**ADDENDUM NUMBER SEVEN (7)  
TO THE PLANS AND SPECIFICATIONS FOR:**

**April 30, 2025**

**City of Port Aransas  
New Recreation Center  
Port Aransas, Texas  
Project No. 23.39**

# Addendum Number 07

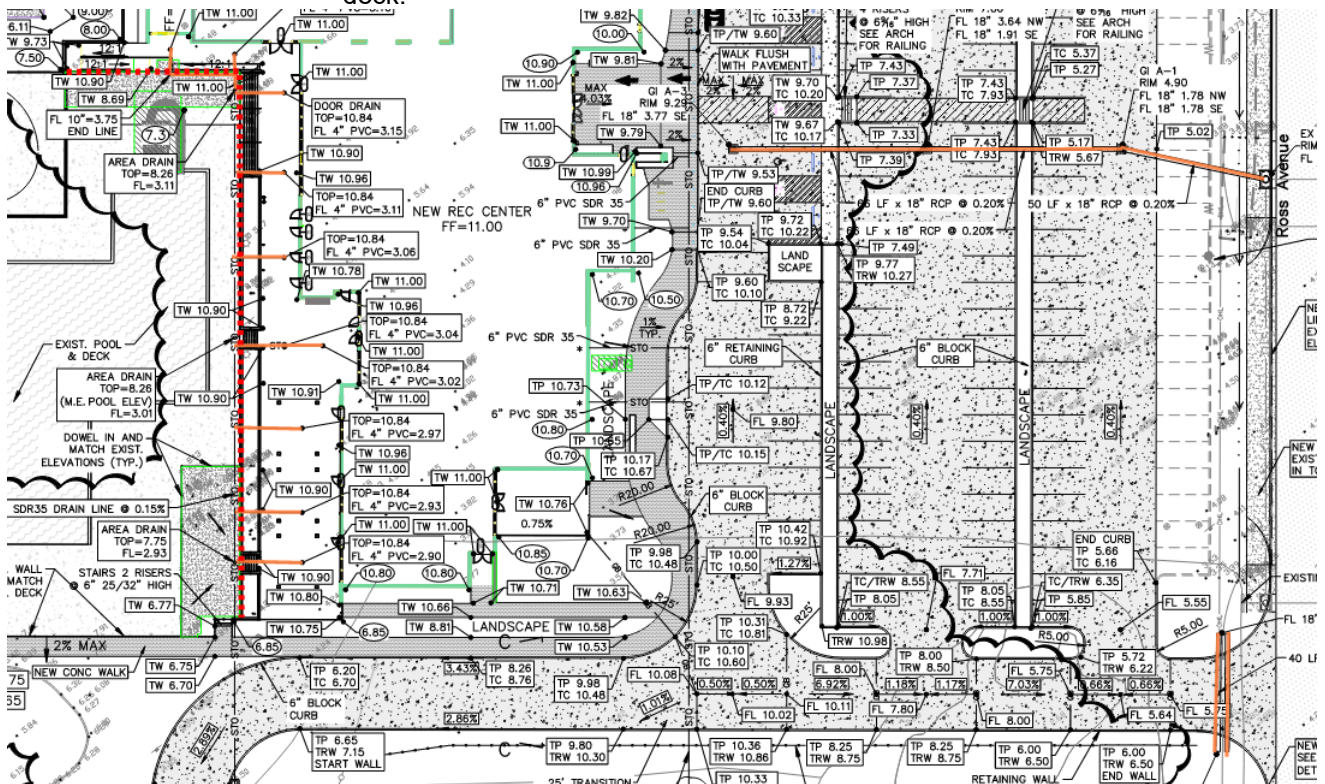
**Question 6:** On CE2.0 in Addendum-05, everything highlighted in orange is not shown on utilities print. Do we include it? And, on sheet CE2.0 it shows culvert pipe crossing the two entrance that or not shown on utilities print. Do we include them, and will they need sloped ends?

**Question 7:** Planter details in Addendum-05 shows trench drain and planter drains. There none shown on the prints.

**Question 8:** On CE2.0 on the highlighted lines by swimming pool it calls for drains. What do we use?

**Response:** Yes. Provide all utilities (incl. storm water) scope shown in the Civil drawings regardless of whether the information is shown on a Grading Plan or a Utility plan. The culvert pipes will need sloped ends. (Reference orange highlighted items in site plan screenshot below).

**Response:** On the trench drains defined in Addendum-05, they are to be provided along the red dashed line in the site plan screenshot below. On the planter drains, the details states that the 3" planter drains are to be provided every 8'-0" o.c. (Min. one per planter). The drains are to be tied into the UG 10" PVC storm line running alongside the plan East side of the existing pool deck.

**Response:** The design intent is to NOT cut into or trench into the existing pool deck. Delete these area drains. The trench drains running alongside the existing pool deck have replaced these area drains. The new 10" storm line will also need to be installed outside of the existing pool structure and directly below the new planters.

**1 1ST FLOOR POWER PLAN**  
SCALE: 3/32" = 1'-0"

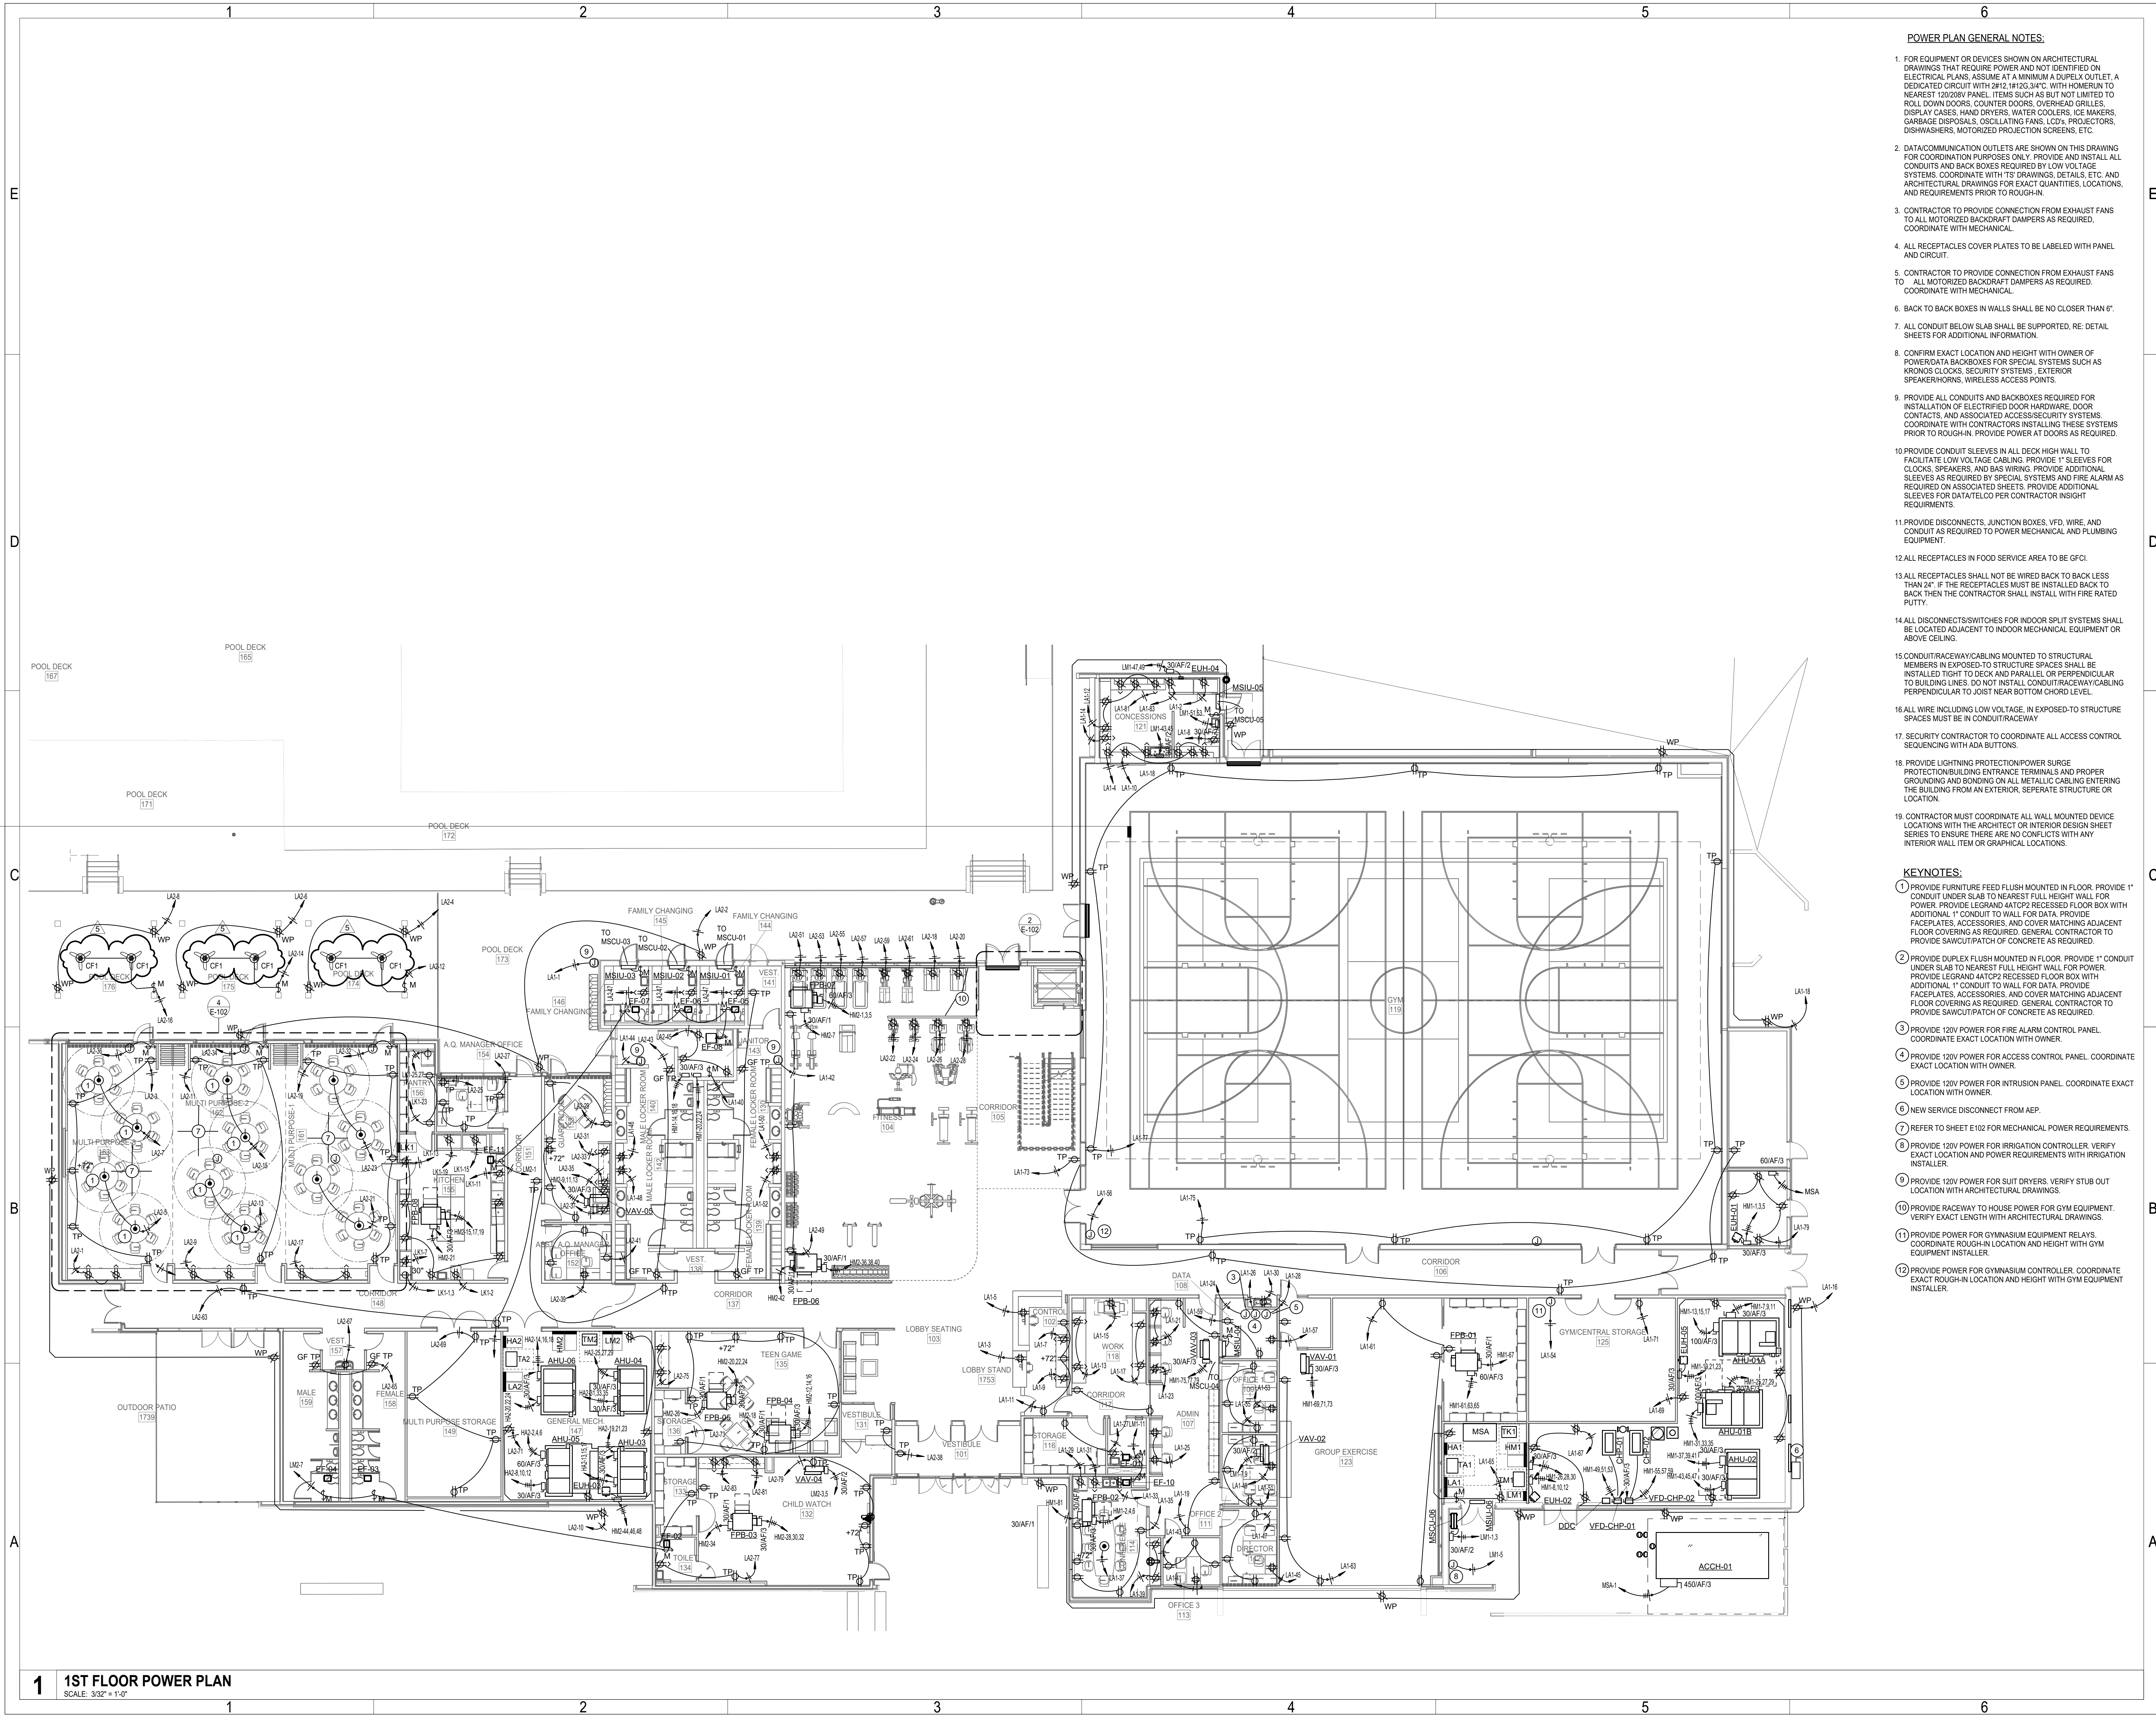
Item No. 05: Re: **E-101 – 1<sup>ST</sup> FLOOR POWER PLAN**

- a) CF2 shall become CF1.
